TRANS/WP.29/GRSG/2003/22/Rev.1
7 April 2004

World Forum for Harmonization of Vehicle Regulations (WP.29)

**PROPOSAL FOR SUPPLEMENT 1 TO THE DRAFT 02 SERIES OF AMENDMENTS TO
REGULATION No. 107**

(M2 and M3 vehicles)

"Figure 11b
SPACE FOR FEET OF SEATED PASSENGERS BEHIND A SEAT AND OR/OR A SEAT
FACING THE GANGWAY
(see annex 3, paragraph 7.7.8.5.2)

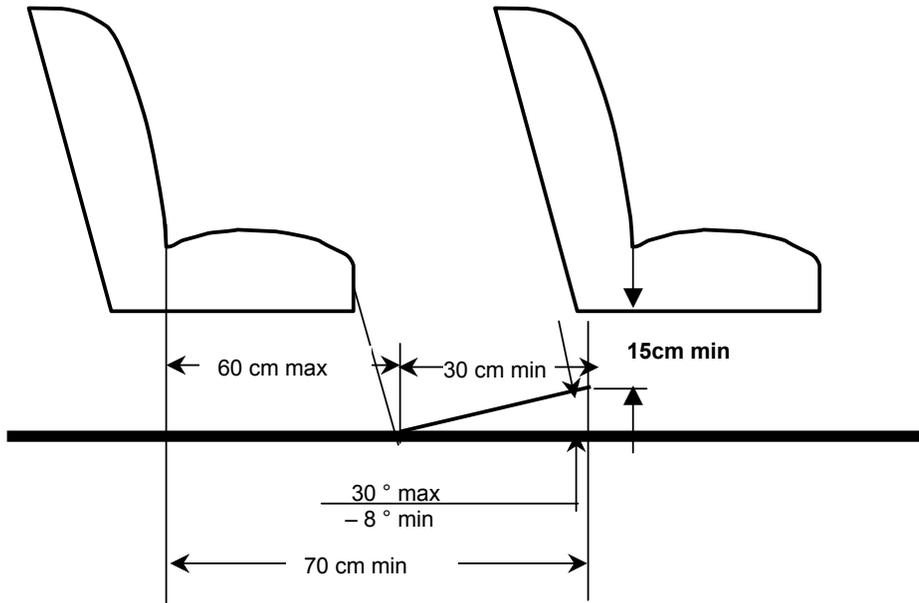
"7.7.8.5.2. **For a seat behind a seat and/or a seat facing the gangway, a minimum clear foot space of at least 300 mm depth and a width according to paragraph 7.7.8.1.1., shall be provided as shown in Annex 4, figure 11b. The local presence in this space of seat legs and of intrusions as provided by paragraph 7.7.8.6. shall be permitted provided that adequate space remains for the passengers' feet. This foot space may partly be situated in and/or above the gangway but shall not create any obstruction when measuring the minimum gangway-width in accordance with paragraph 7.7.5. In the case of seats alongside the driver's seat in vehicles with up to 22 passengers,** intrusion of the seat belts and seat belt anchorages shall be allowed. "

Insert a new figure 11b, to read: **

"Figure 27
ACCESS TO DRIVER'S DOOR
(See Annex 3, paragraph 7.6.1.7.2.)

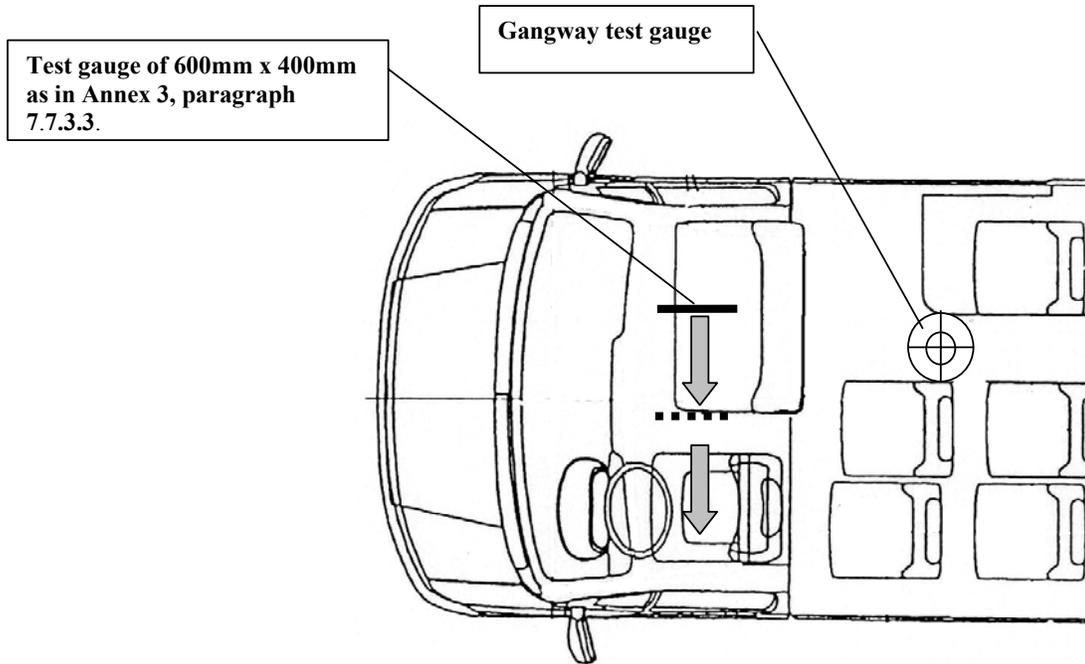
The driver's door shall be accepted as the emergency door for the occupants of those seats, provided that **it is possible to move a test gauge from the occupants' seats to the exterior of the vehicle through the driver's door (see annex 4, figure 27).**

Insert new figures 27 and 28, to read: ***

Figure 28
ACCESS TO DRIVER'S DOOR
(See Annex 3, paragraph 5.7.2.4.2.)

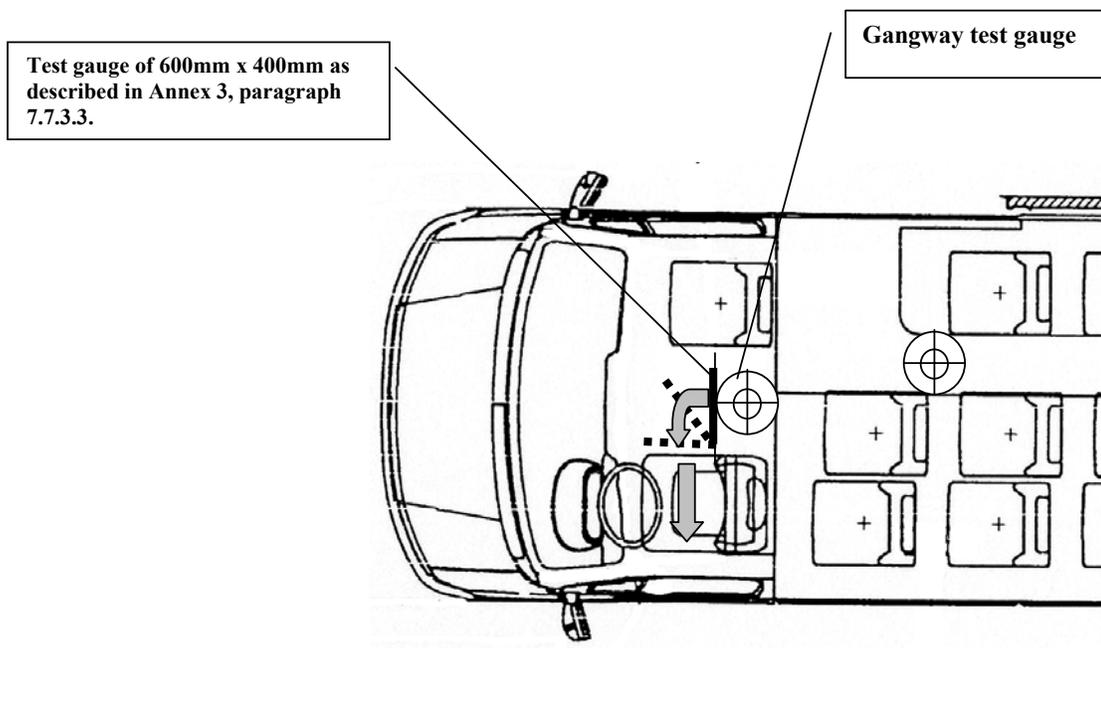
"7.6.1.9.3. **the space reserved for the driver's seat shall communicate with the main passengers' compartment through an appropriate passage; such requirement shall be deemed to be fulfilled if the test gauge described in paragraph 7.7.5.1. can move unobstructed from the gangway, until the front end of the gauge reaches the vertical plane tangential to the foremost point of the driver's seat back (this seat being situated in its rearmost longitudinal position) and, from this plane, the panel described in paragraph 7.6.1.7.2. could be moved to the emergency door in the direction established by such paragraph (see annex 4, figure 28) with seat and steering wheel adjustment in their mid position."**

**"Figure 1
ACCESS TO SERVICE DOORS**

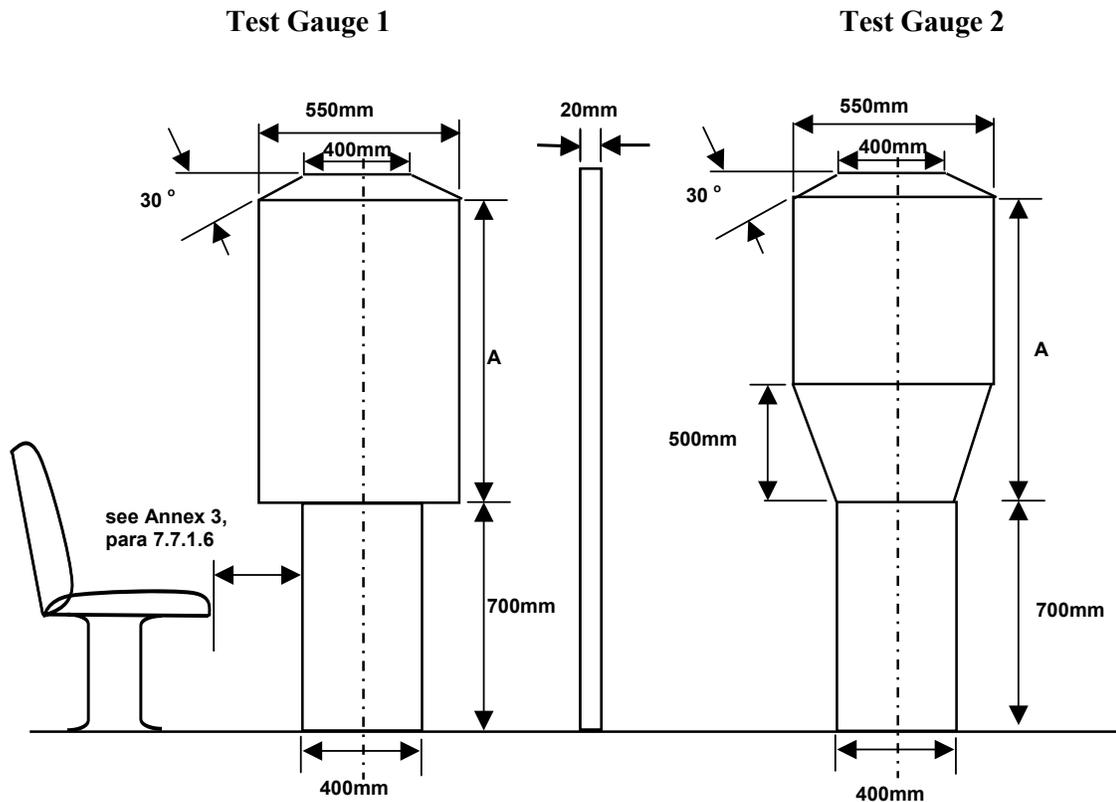
"7.7.1.1. The free space extending inwards into the vehicle from the side wall in which the door is mounted shall permit the free passage of **one test gauge having the dimensions of either test gauge 1 or test gauge 2 specified in annex 4 figure 1.**

Figure 1, amend to read:

Re. Figure 1:

Figure redrawn to correctly reflect text and to transfer detail from text to diagram in accordance with past GRSG decision.
